DOCUMENT CHANGE REQUEST

DCR number 371	Changes required for: N/A	Originator: andre UGUEN
Date: 2007/07/25	Date sent: 2007/07/25	Organisation:
Status: IMPLEMENTED

Title:	CMOS 8-Stage Shift and Store Bus Register with Synchronous Serial Outputs and 3-State Parallel		
Number:	9306/026	Issue:	2

1.10 TRUTH TABLE AND TIMING DIAGRAM
page 14

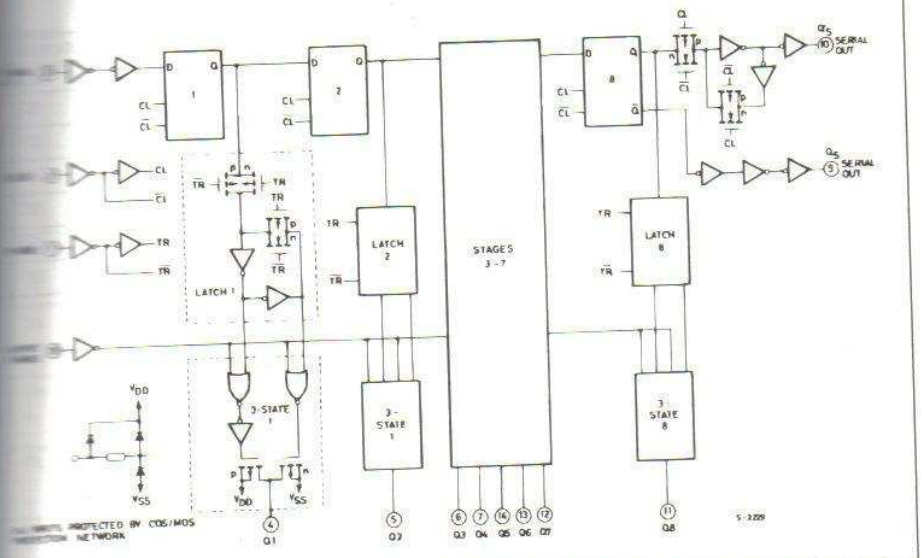
timing diagram is wrong.

during migration from old ESA/SCC form to ESCC form, the diagram was copied and an error was introduiced: the second negative pulse of STR shall start at the next falling front of CLK (in the same time as OE).
Good diagram is proposed in attached file
